**EIR Addendum**  
**San Pedro Waterfront Project, Harbor Boulevard/7<sup>th</sup>  
Street/Sampson Way Intersection Improvements**  
*[SCH No. 2005061041, APP No. 041122-208]*

*Prepared by Los Angeles Harbor Department  
Environmental Management Division  
June 22, 2015*

#### IV. Proposed Project Modification: Modified Design for Harbor Boulevard/7<sup>th</sup> Street/Sampson Way Intersection Improvements

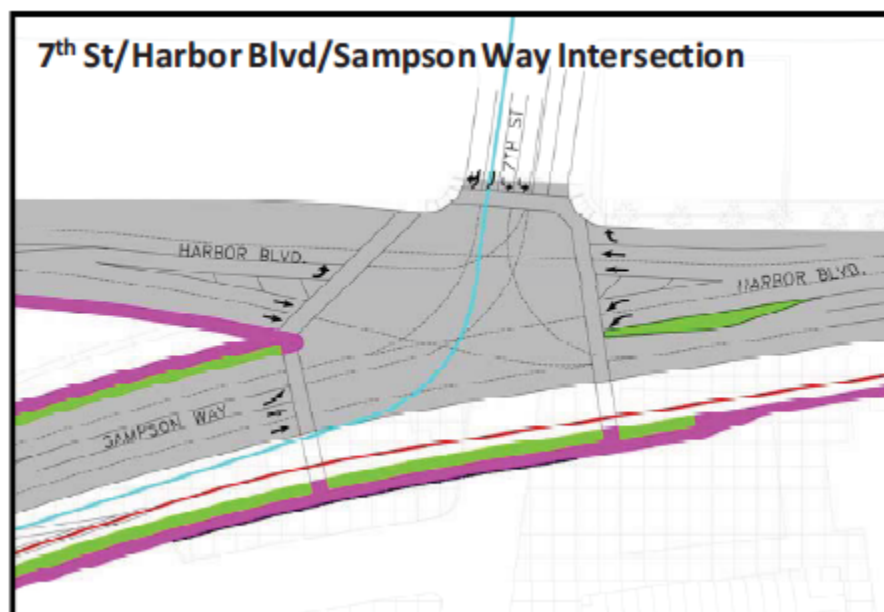
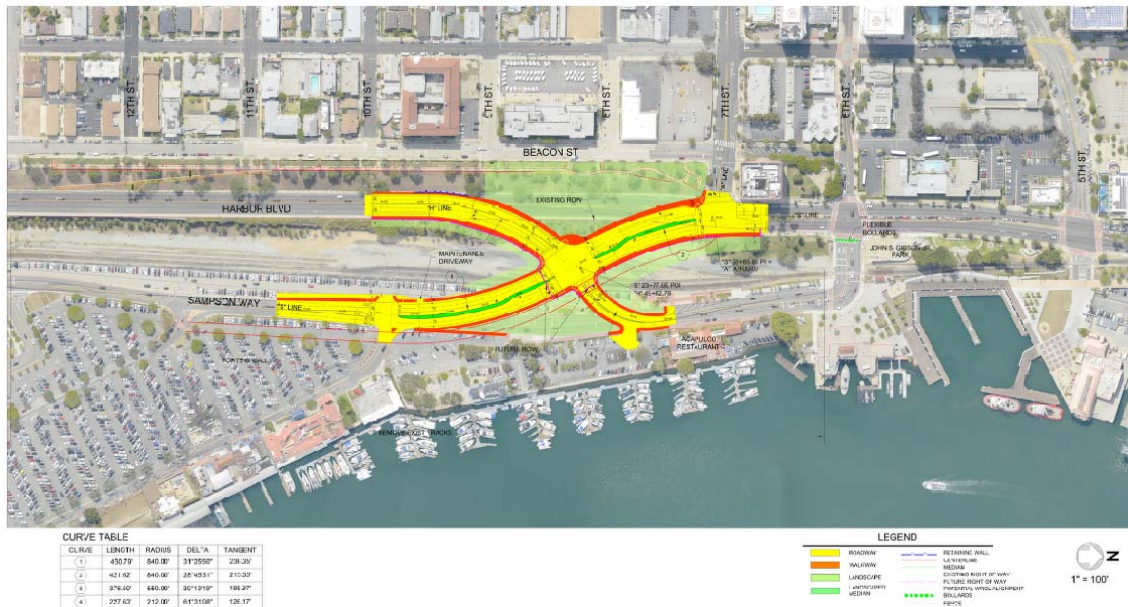
The Final EIR assumed construction of an enhanced four-way intersection at Sampson Way and 7th Street to provide improved access to and along the waterfront. It also included a modification of the 6th Street connection to Sampson Way which would eliminate access to Sampson Way from Harbor Boulevard via 6th Street. The modifications would result in two through lanes in each direction on Sampson Way and two through lanes in each direction on Harbor Boulevard as depicted below:

Through a public participation process that involved workshops and community input between November 2010 and November 2011, the LAHD revised its design for the Harbor Boulevard/7th Street/Sampson Way Intersection to facilitate public access throughout the waterfront area and better connect the waterfront with downtown San Pedro and the surrounding community. The proposed modification is a revised design to shift the intersection further south of 7<sup>th</sup> Street and improve vehicular access to and along the waterfront and provide additional pedestrian access. The project will also improve safety for pedestrians and vehicles by providing signalized intersections,

shorter-distance striped crosswalks, designated bike lanes, continuous pedestrian pathways. The modification of the 6<sup>th</sup> Street connection to Sampson Way which eliminates access to Sampson Way from Harbor Boulevard via 6<sup>th</sup> Street remains in the project as mentioned above. The revised design for the intersection of Harbor Boulevard/7<sup>th</sup> Street/Sampson Way is depicted below:

The project entails realignment of two major arterials in San Pedro, resulting in new/improved signalized intersections of east-west collector streets serving downtown San Pedro, the USS Iowa, the World Cruise Center, and the Ports O'Call. The project includes a reconfigured signalized intersection at the junction of Harbor Boulevard/ Sampson Way/7<sup>th</sup> Street. Expanded to two lanes in each direction, Sampson Way will sweep by Ports O' Call Village along an expansive curve. Harbor Boulevard will remain in place to the north and south of the intersection but will curve eastward from both directions to meet the new intersection which will have a new signal.

The modified alignment would create open space west of the alignment where Harbor Boulevard currently exists. This portion of Harbor Boulevard would be vacated and would be converted into a 0.6-acre extension of Plaza Park including ground cover, ADA paths, steps, plaza area, lighting, trees, short retaining wall, gentler slope, drainage ditch, and irrigation along the newly aligned roadway.

The modified alignment involves utility relocation, a new drainage outlet, landscaping (indicated by the green strip in figure above), and lighting and will provide widened sidewalks and bike paths and more protection for pedestrians than the current condition. It will require the permanent relocation of two bus stops. The new connection of Harbor Boulevard and Sampson Way at 7th Street will provide a gateway to the waterfront and improve access to Plaza Park with bike lanes, access ramps, and wider sidewalks.
